**EAST GOSHEN TOWNSHIP
PLANNING COMMISSION
Meeting Agenda
Wednesday, February 1, 2017
7:00 PM**

SUBDIVISION AND LAND DEVELOPMENT PLAN
(PRELIMINARY/FINAL) FOR
BRAKMAN PROPERTY

ENTRANCE DRIVEWAY PLAN & PROFILE

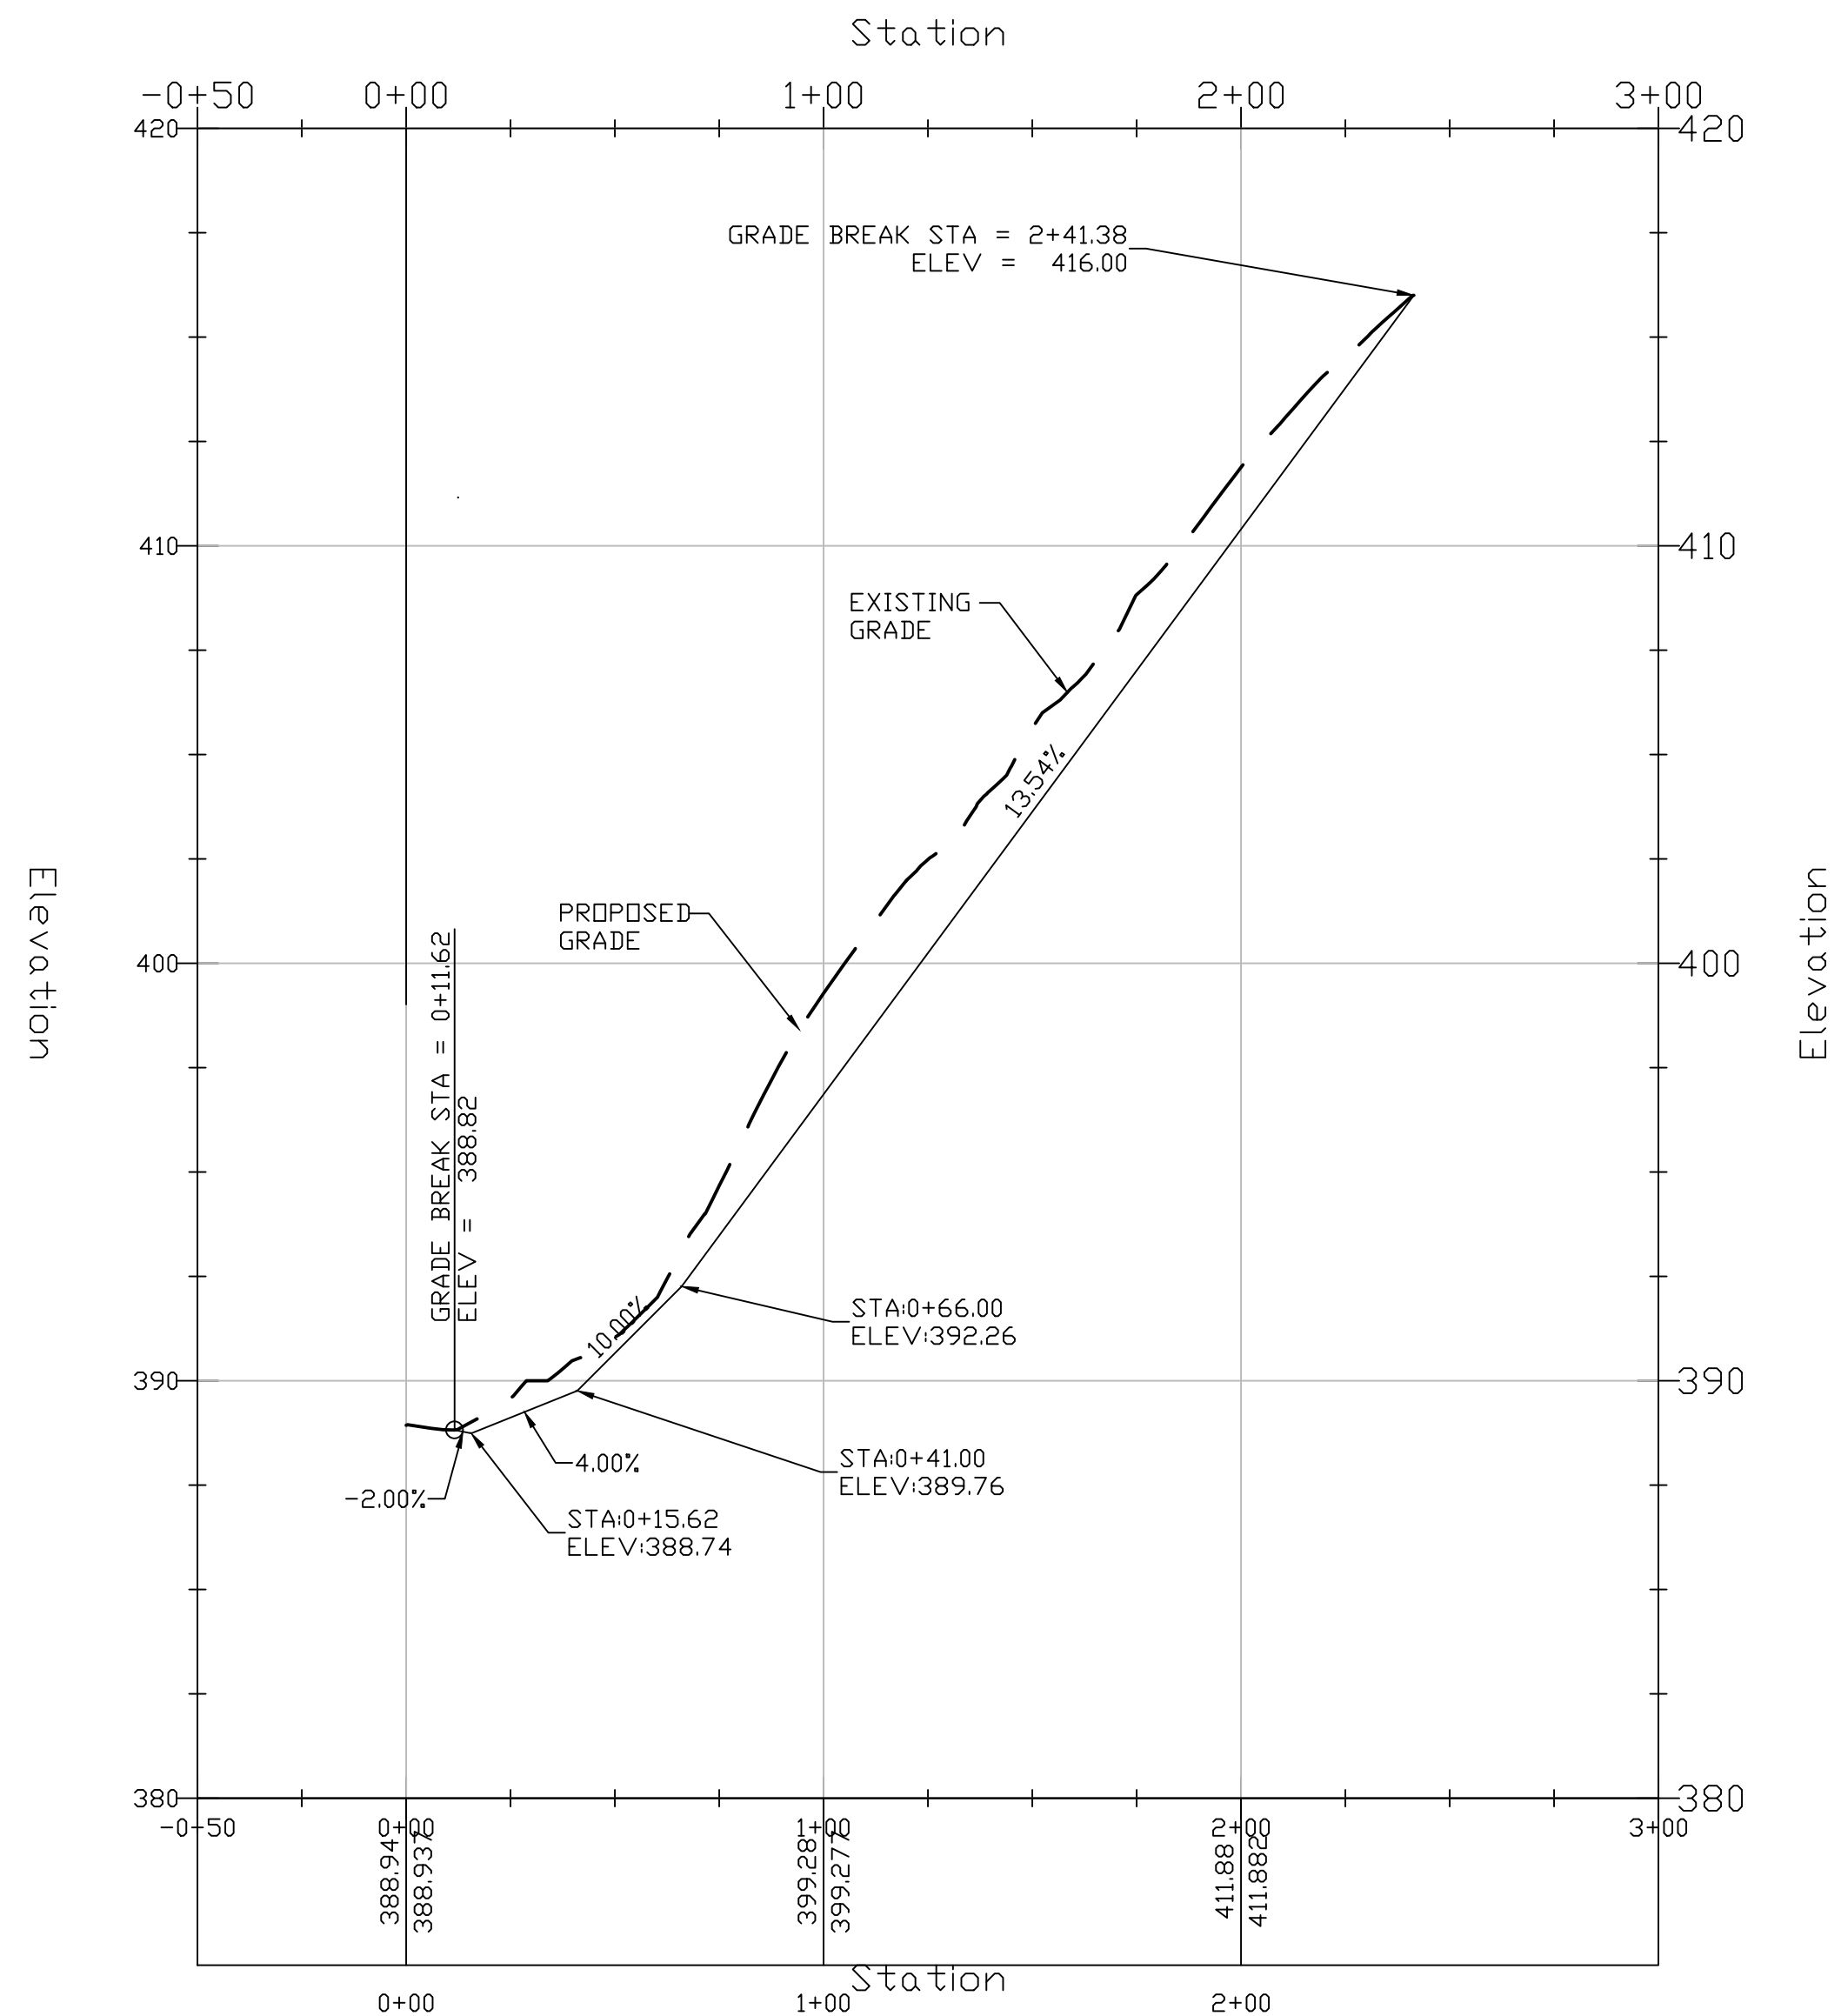
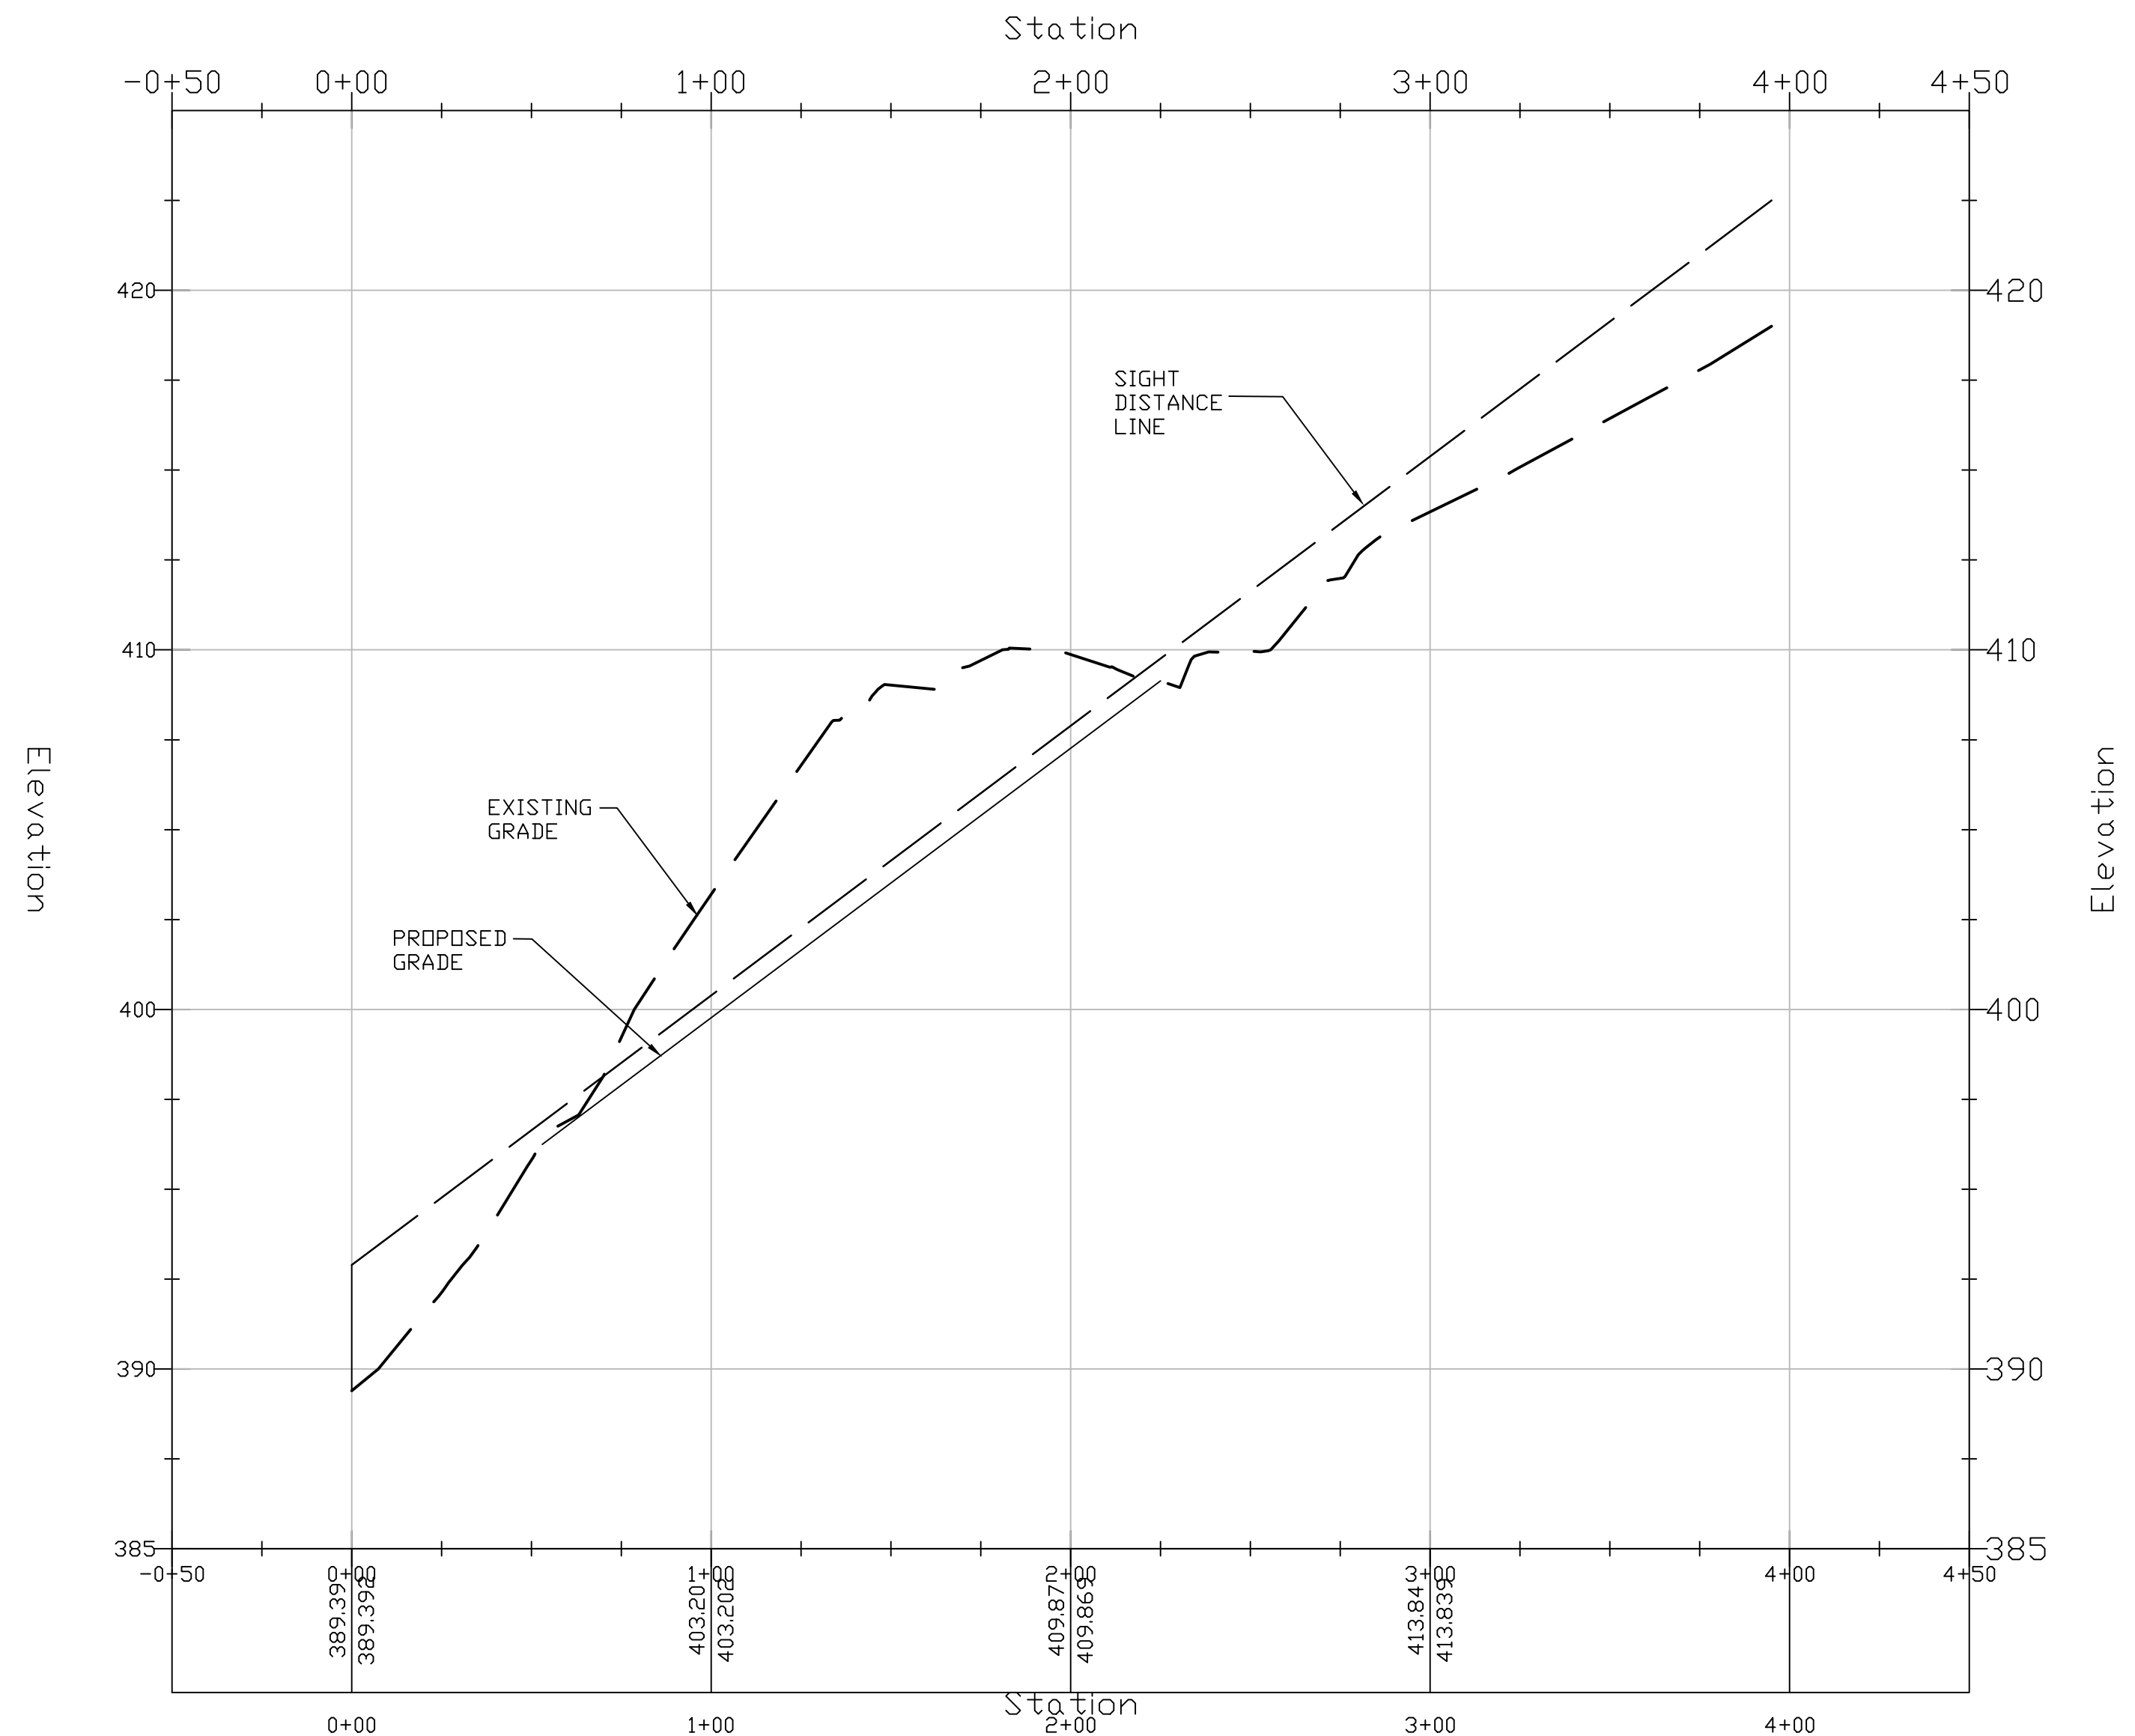
10. A Sight Distance Note was added to Sheet 9 as requested. This note should appear on a plan that is to be recorded.
11. A Landscaping Note appears on Sheet 11 indicating foundation plantings are to be provided by the builder. A plan should be provided indicating proposed plantings.

The Applicant previously provided a Tree Survey Plan and Tree Survey Count of all trees and their conditions, and has updated the plans accordingly. On Sheet 9, the Applicant indicates there are 375 existing trees. However, per the definition, trees that are dead, invasive or within the street right-of-way do not count towards

the total count. Please revise the calculation on Sheet 9 accordingly. Note further that lines 139-147 are missing in the previously provided Tree Survey Count.

1. **A note labeled as "Sight Distance Note" has been added to Sheet 9.**
